Technical Note

To Rebecca Harrison (Gravesham BC); Emma England (KCC); Helen Forster (KCC)	Project name TKRE Cable Tunnel	Client National Grid	Subject Response to Ecological Points Raised in KCC Advice to Gravesham BC Dated 27 February 2024
Date 24th July 2024	Prepared by John Simmons	Revision No. 02

FIGURE NUMBER
Figure 1

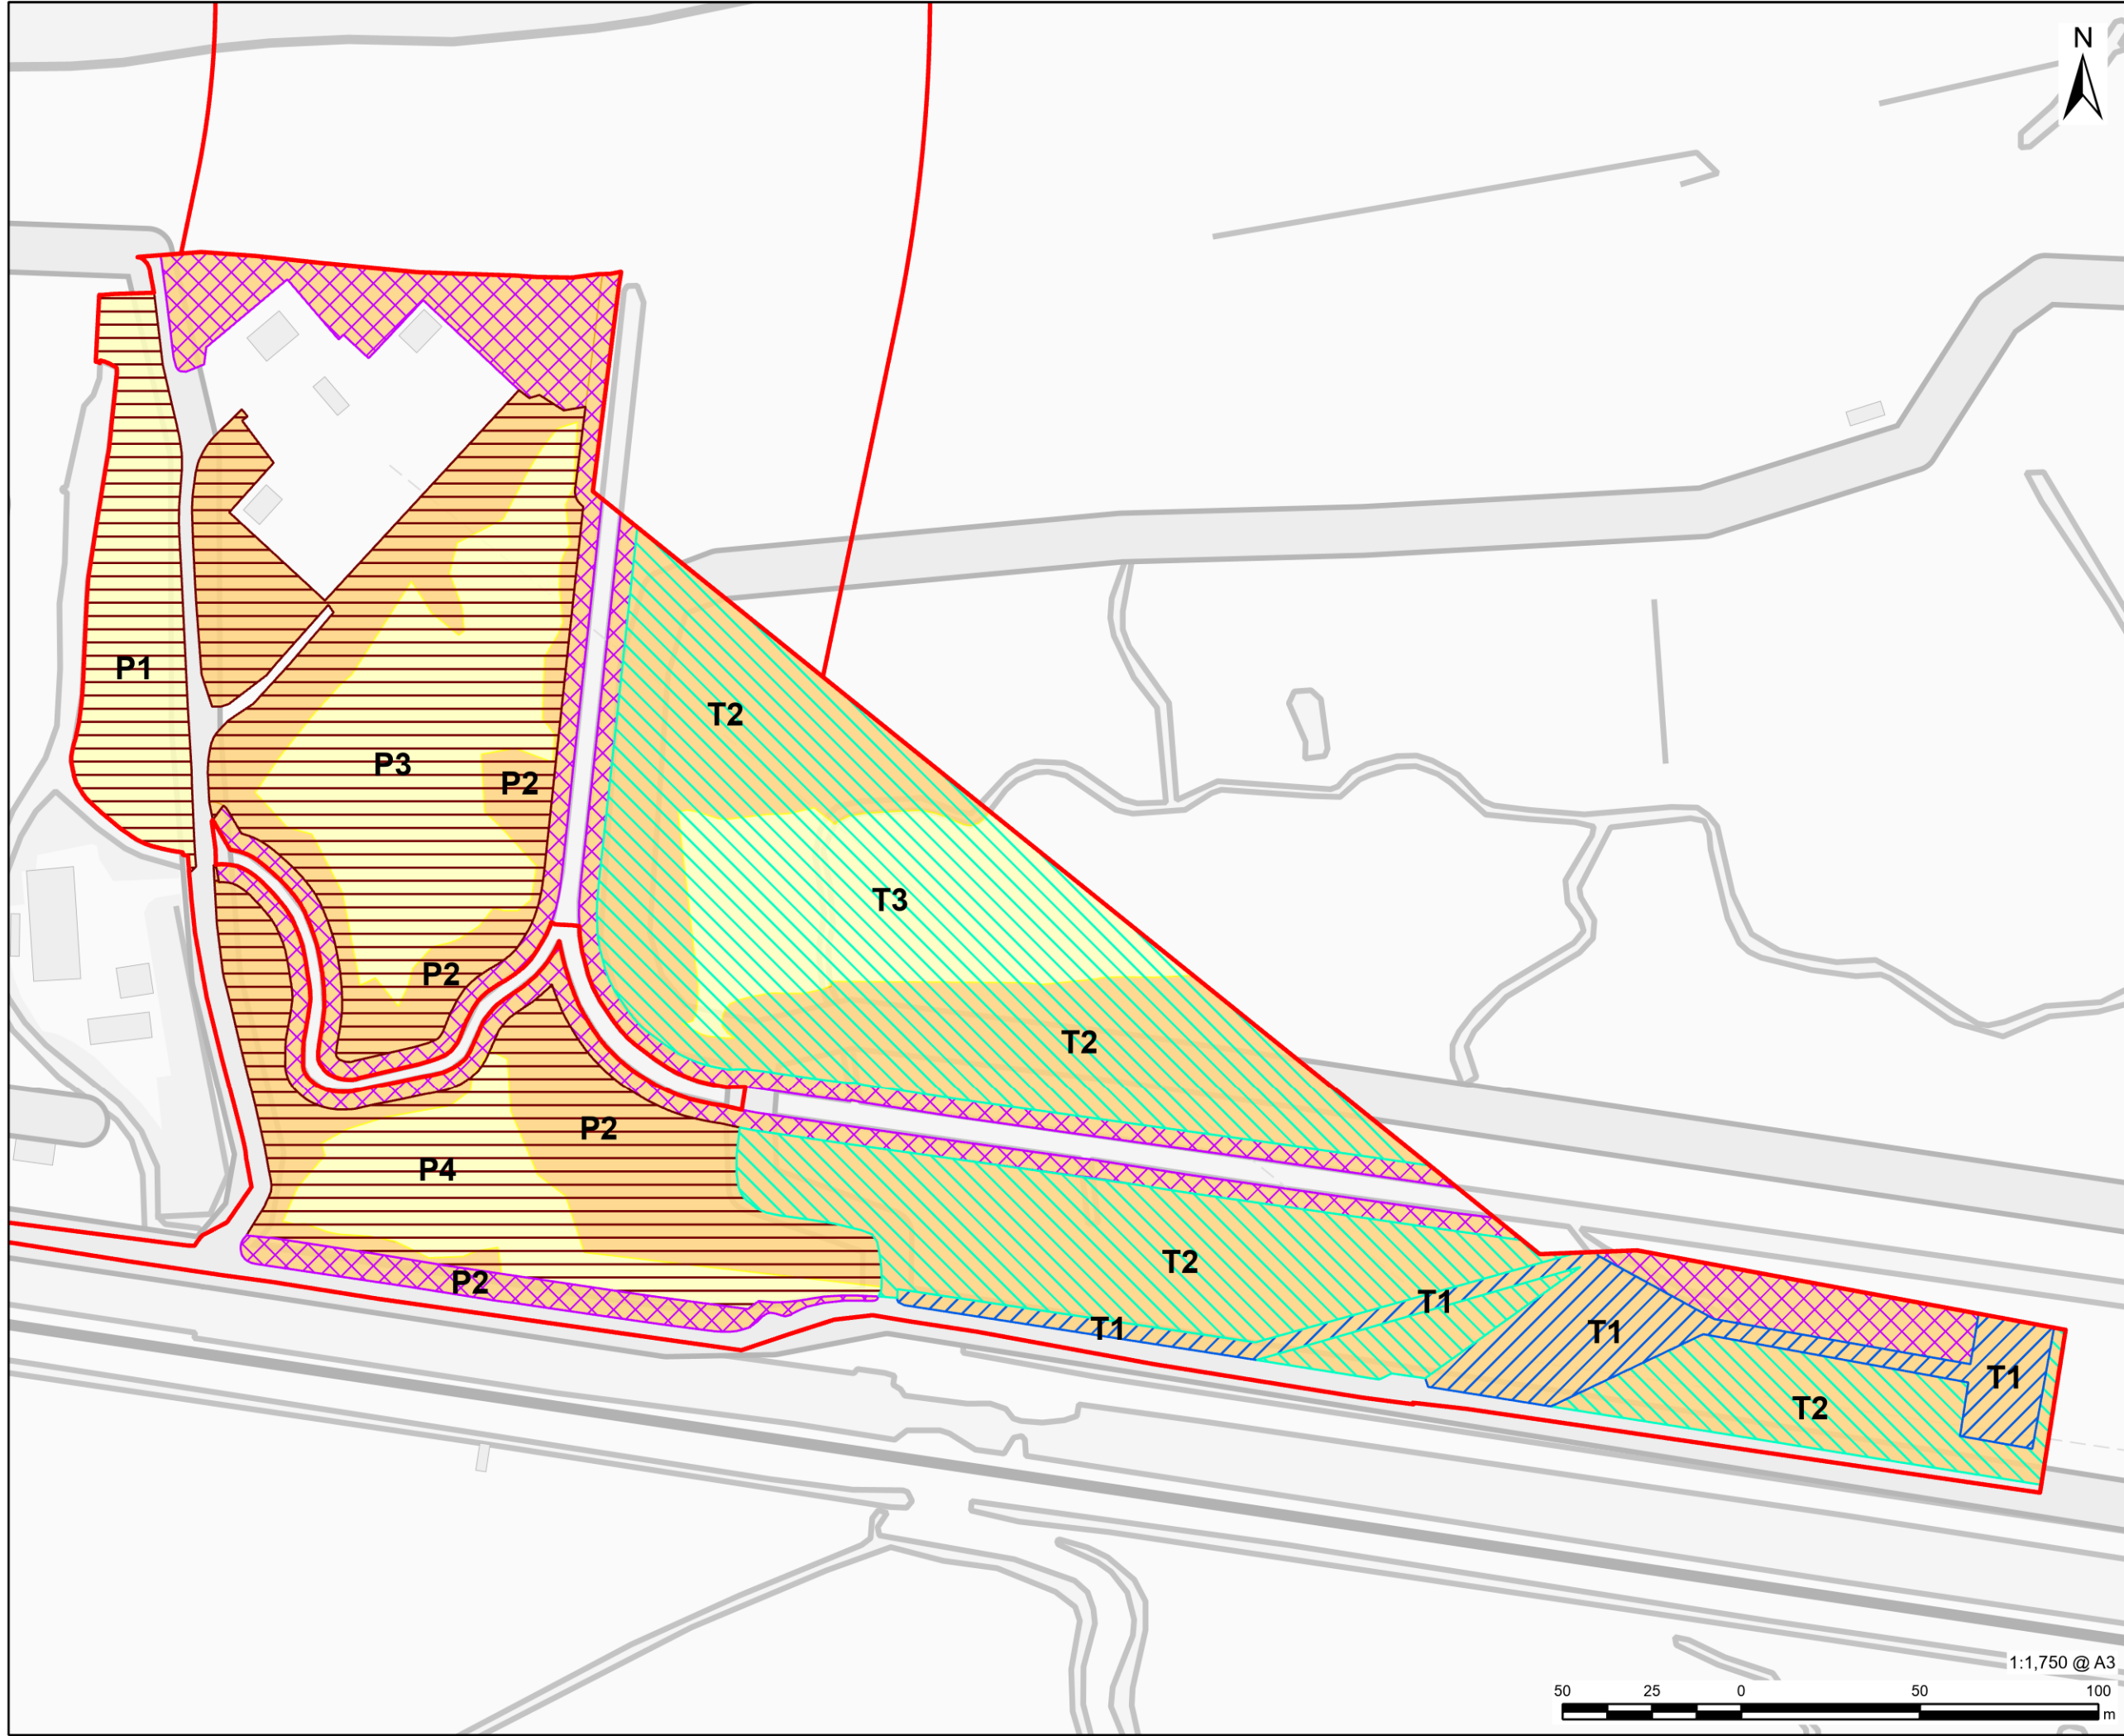
It is noted that the areas of habitat loss set out within paragraph 15.9.26 of the ES are the *total* areas of all habitat that will be permanently or temporarily lost due to the Proposed Development. However, it should be noted that these areas vary considerably in their suitability to support common reptiles. In order to provide further detail, we have documented the reptile suitability of the habitats currently present and the scale of the losses that would occur in Figure 1 attached and Table 1 below.

Some smaller areas in the field to the south of the rifle range (0.4ha – see Table ; Figure 1 reference T1) will require temporary ground disturbance in order to install a temporary access road, crane pad and laydown area for materials.

The remainder of the areas of long sward grassland impacted by temporary works (2.2ha of habitat to be cut back to enable OHL works and 0.4ha disturbed due to access tracks/crane pads/laydown areas – see Figure 1 reference T2) , with a single area of shorter grassland associated with the rifle range (0.6ha habitat to be cut back temporarily to enable OHL works – area T3 Figure 1). The longer sward areas of grassland are suitable to support common reptiles and provide good foraging habitat. However, within the fields to the south of the rifle range in particular, there is an absence of shorter sward areas suited to basking, and suitable hibernation habitat/refugia is limited to scattered scrub associated with the boundaries of the Site. These factors are likely to limit the reptile population that can be supported.

The area to the west of the existing electrical compound (Figure 1, reference P1) consists of a bank dominated by a dense stand of hemlock. This area is also considered to be of low suitability for reptiles based on dense and uniform stand providing shading at ground level.

The margins of the fields in the west of the Site, including the interface with drainage ditches (Figure 1 reference P2) , support a combination of longer sward areas of grassland, tall ruderals and scrub. These areas are disturbed less frequently by grazing and are considered to be of moderate suitability for reptiles.

As detailed in Table 1, the Proposed Development will result in the permanent loss of approximately 1.4 ha of low suitability reptile habitat (see Figure 1 reference P1, P3 and P4). Based on the nature of the habitats in these areas (predominately pony grazed grassland), these areas are considered likely to be used by only very low numbers of reptiles (if any), with those individuals being primarily associated with the adjoining areas of more suitable habitat. In isolation, they would be considered of negligible suitability.

The losses of reedbed habitat identified within the BNG calculation are small areas of reed dominated grassland in the fields that will be used as a construction laydown area (Figure 1, reference P4). These areas are infrequently wet. They were checked during water vole surveys undertaken in 2023 and were deemed unsuitable for use by water vole.

The route of the temporary access road, crane pad and laydown areas (Figure 1 reference T1) will be reinstated on completion of the works. Natural regeneration of these areas is proposed, and these small areas (0.4ha) are likely to return to their original condition within 12-24 months.

Throughout the works a buffer of suitable reptile habitat will be maintained around the northern margin of the southern fields (minimum width 5m) which will maintain connectivity with larger areas of retained suitable habitat to the east and northeast. Within the rifle range, connectivity will be maintained with large areas of similar habitat to the north and east outside of the planning red line boundary.

In order to increase the suitability of the retained 5m marginal areas we propose creating eight log/brush piles (each measuring approximately 2m x 2m x 0.5m height) to further enhance structural diversity and provide shelter/hibernation habitat. Where necessary, the 5m marginal areas will also be enclosed by temporary fencing (electric fence or netlon) to ensure that these areas remain undisturbed by pony grazing and therefore maximise their value for reptiles prior to commencement of habitat clearance.
